In Reply Refer To:  
HSST/WZ-311

Name of system:	STF18 with Extended Mast
Type of system:	Portable X-footprint sign stand for roll-up signs
Test Level:	NCHRP Report 350 Test Level 3
Testing conducted by:	N/A
Date of request:	October 11, 2011
Date initially acknowledged:	November 15, 2011
Date of completed package:	October 11, 2011

# STF18 with Extended Mast

## STF18 STAND with Extended Mast

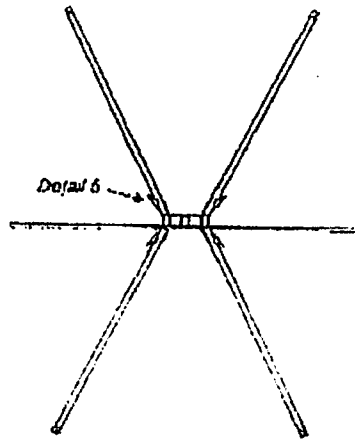
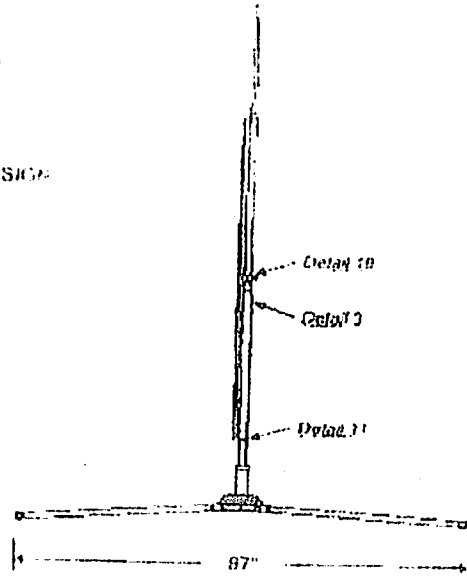
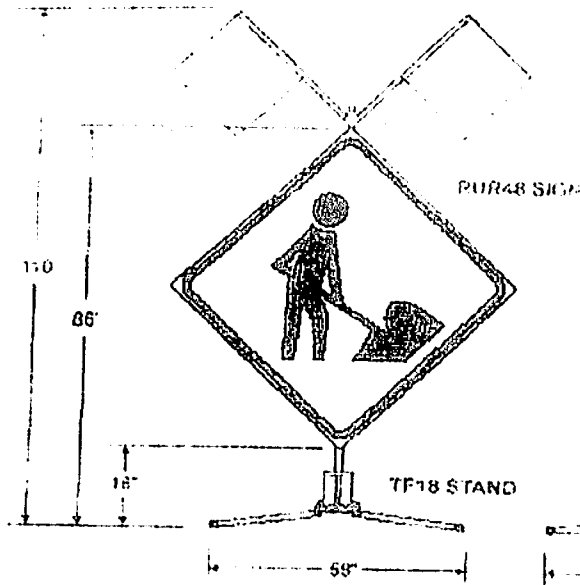
Based on the enclosed information and previous test data, we are seeking acceptance of sign stand "STF18 with an Extended Mast" to hold roll-up signs 84 inches above ground. We believe this to be a reasonable request because this stand is a combination of previously accepted base and mast designs. Therefore this new stand will incorporate an accepted design below the height of the vehicle bumper and an accepted mast that will have no effect on the windshield impact data.

Based on a review of the analysis submitted by the manufacturer certifying the device described herein meets the crashworthiness criteria of the National Cooperative Highway Research Program (NCHRP) Report 350, the device is eligible for reimbursement under the Federal-aid highway program. Eligibility for reimbursement under the Federal-aid highway program does not establish approval or endorsement by the FHWA for any particular purpose or use.
